Subject: Response to Request for Additional Information (RAI) Letter No. 8 –  
Exelon Early Site Permit (ESP) Application for the Clinton ESP Site  
(TAC No. MC1122)

Re: Letter, U.S. Nuclear Regulatory Commission (N. V. Gilles) to Exelon  
Generation Company, LLC, (M. Kray), dated July 27, 2004, Request for  
Additional Information Letter No. 8 – Exelon Early Site Permit  
Application for the Clinton ESP Site (TAC No. MC1122)

Enclosure: Response to RAI 1.4-1  
Response to RAI 1.4-2  
Response to RAI 2.1.1-1 and associated attachment  
Response to RAI 2.1.2-1  
Response to RAI 3.3-1  
Response to RAI 3.3.1-1  
Response to RAI 3.3.2-1  
Response to RAI 3.3.4-1  
Response to RAI 3.3.4-2 and associated attachment  
Response to RAI 3.3.4-3

**Figure 2.1-8**  
**ESP Exclusion Area Boundary and**  
**Low Population Zone**

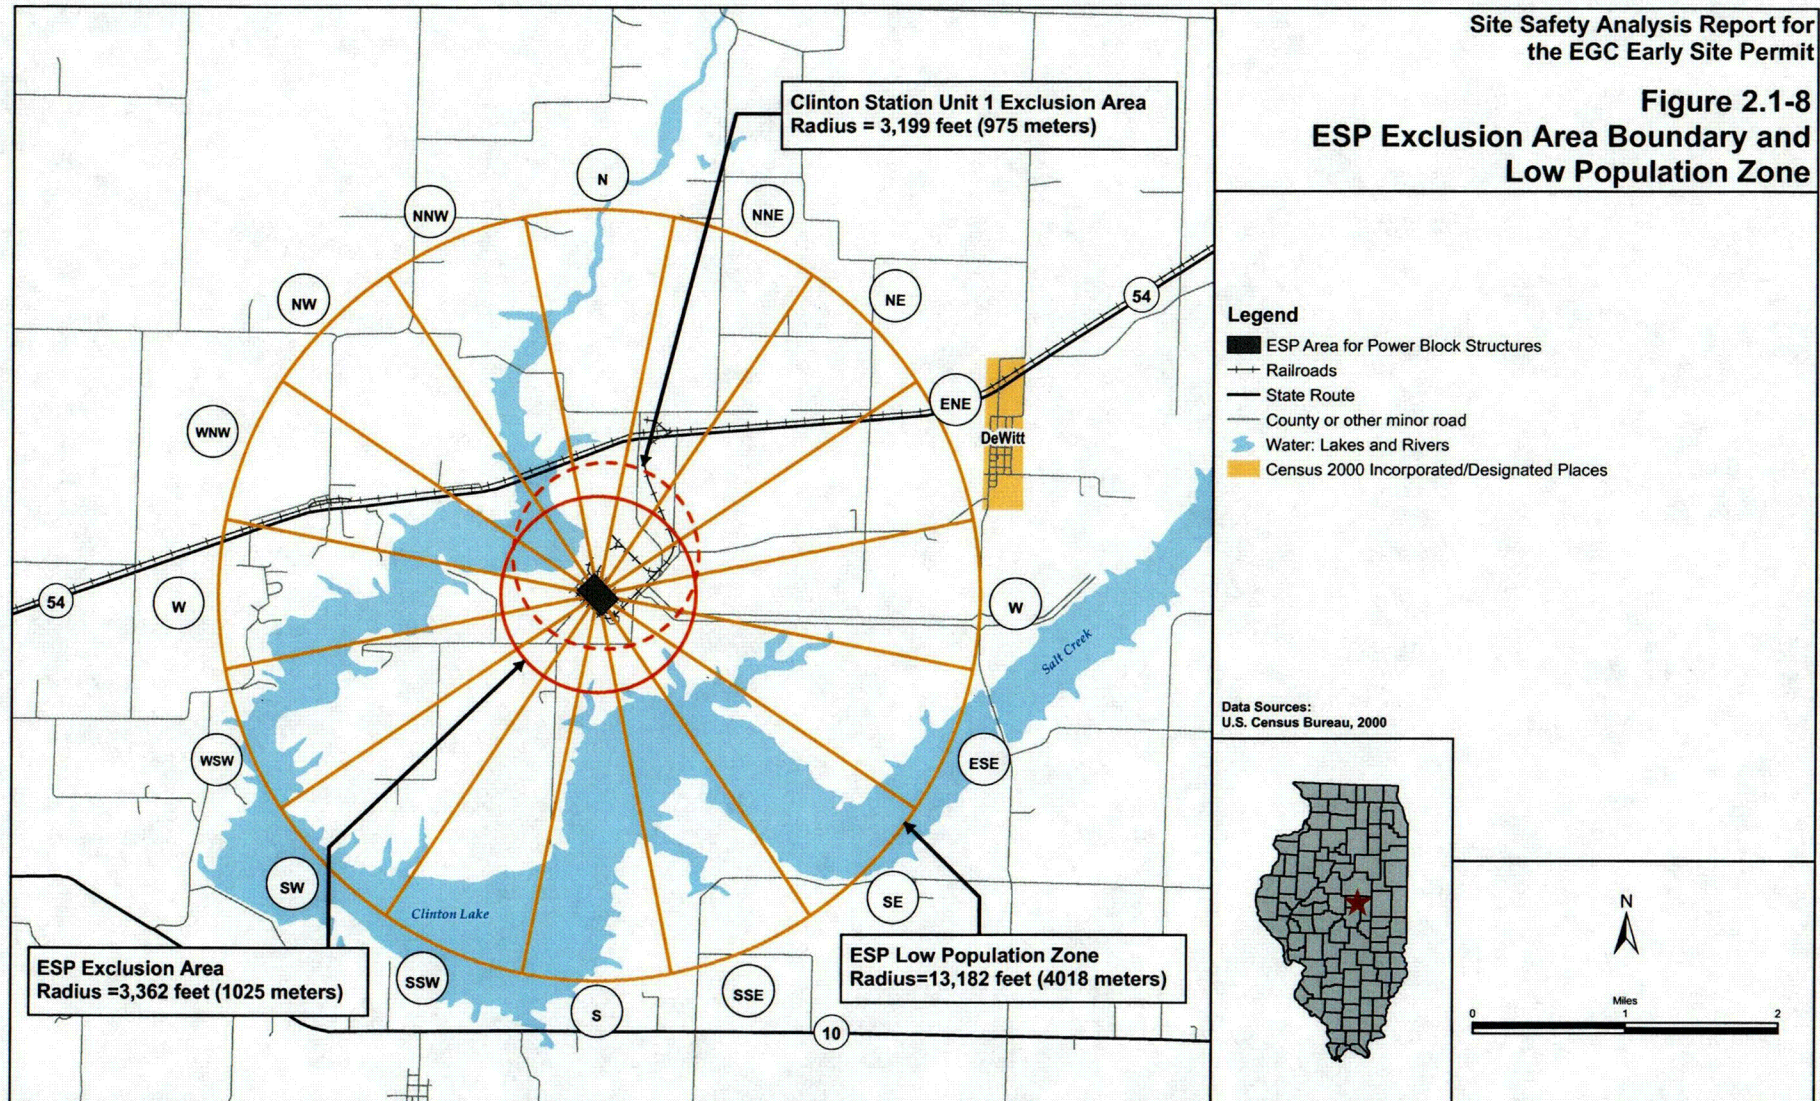
SSAR Figure 1.2-3 shows the proposed ESP exclusion area boundary (EAB) and low population zone (LPZ), and the distances to the EAB and LPZ by sector. Please provide an expanded and legible figure to clearly show the proposed EAB and LPZ as well as existing Clinton Power Station EAB. Please provide the direction distances to the EABs and LPZ by sector. Please state the distance from the proposed ESP site to the nearest EAB line for the proposed ESP site, including its direction and distance.

SSAR, Chapter 2, Figure 2.1-8 (as attached to this RAI response) has been provided to more clearly show the proposed ESP exclusion area boundary (EAB) and low population zone (LPZ) as well as the existing Clinton Power Station EAB. The ESP EAB is based on maintaining a minimum distance of 0.5 miles (805 meters) from any point on the ESP Plot Plan for locating the Power Block Structures. This resulted in an exclusion area with a radius of 1025 meters for the EGC ESP site. The LPZ was maintained at a distance of 2.5 miles (4018 meters) since this area contains residents whose total population and density are such that there is reasonable probability of providing appropriate protective measures based on both the Clinton Station Emergency Plan (EP) and EGC ESP major features EP documentation.

Revise SSAR, Chapter 2, Section 2.1, to add new Figure 2.1-8 as provided in the attachment to this RAI response.
